BTB 51769-51809 (1406) REV1

Safety Recall: ILX Headlights

Supersedes 14-018, dated June 13, 2014, to revise the information highlighted in **yellow**.

REVISED ILLUSTRATION

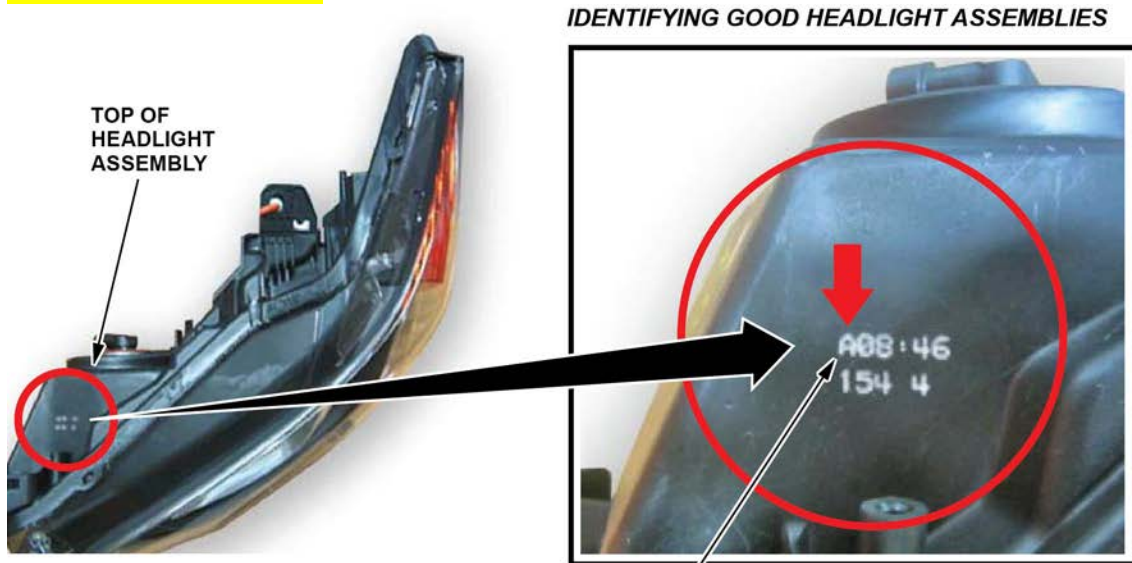
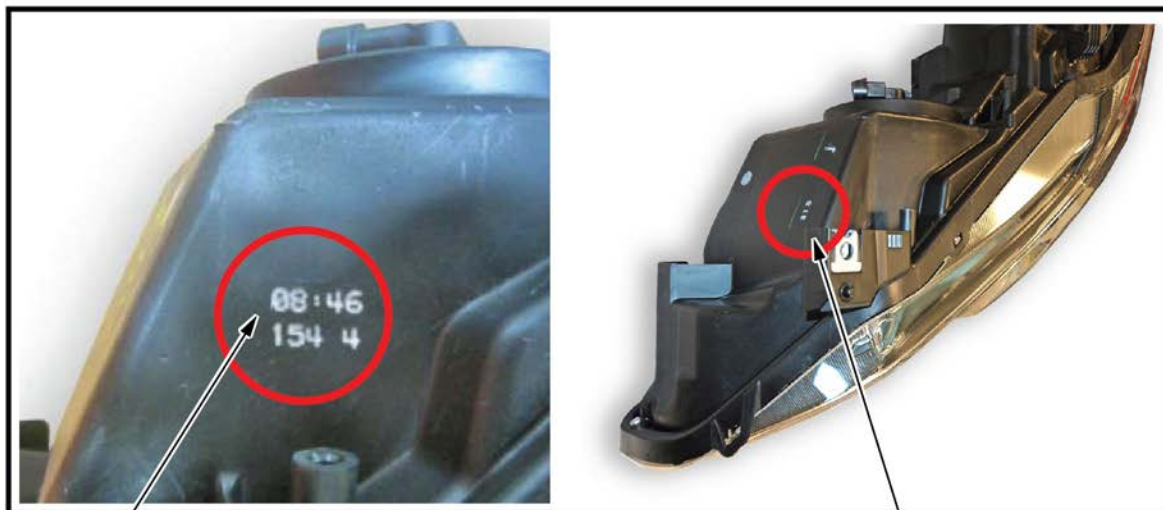
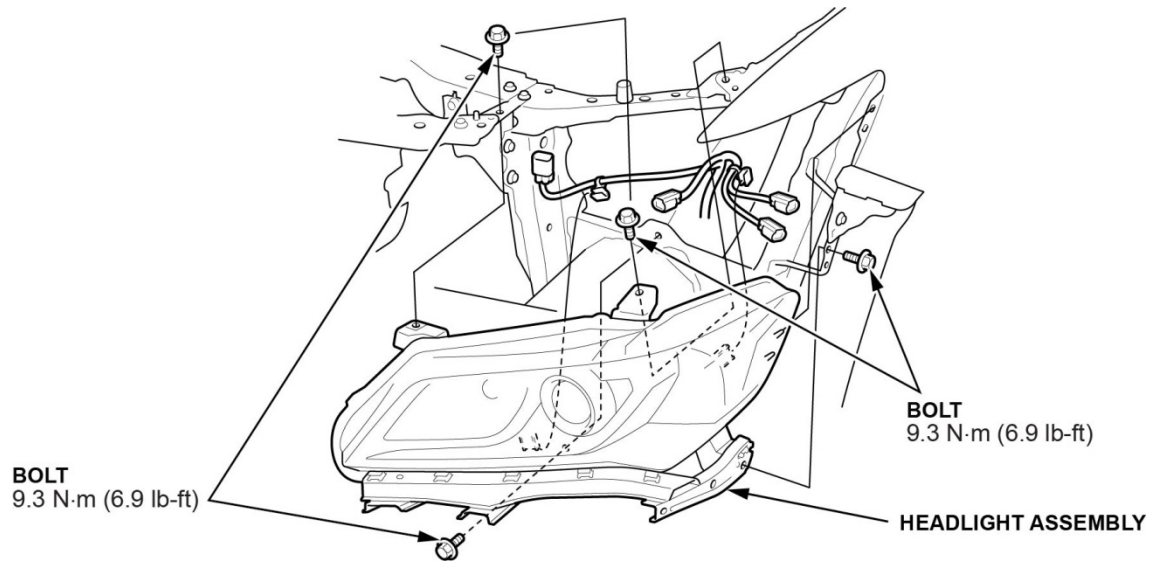
In step 4 under NOTE, the illustration was changed.

NOTE: Just in case the headlight assemblies get mixed up on your work bench, the improved head light assemblies have the letter (A) in front of the date code.

IDENTIFYING GOOD HEADLIGHT ASSEMBLIES

Look for an "A" in front of the date code.

IDENTIFYING HEADLIGHT ASSEMBLIES TO BE REPLACED

FACTORY ORIGINAL HEADLIGHT ASSEMBLIES
No "A" in front of date code.

NO-GOOD SERVICE PARTS
Date code is on the side of the assembly.
